QUARANTINE NOTICE

| Reference number: | QN-01-1546 | Issued: 31 August, 2021 |
| Subject: | Install New Screws for the Front Splitter | |
| Model(s): | Vantage F1 Edition | |

Figure 1

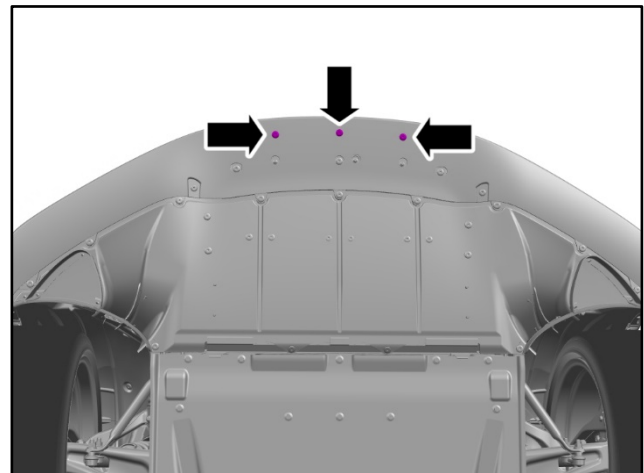
Aston Martin has identified some Vantage F1 edition vehicles that may not have the correct front splitter screws installed. To correct this problem, do the workshop procedure that follows.

1. Lift the vehicle and make it safe.
2. Remove the incorrect screws for the front splitter (refer to Figure 1).
If the screws for the front splitter are not installed go to step 3.

3. Install the correct screws to the front splitter.
4. Lower the vehicle.
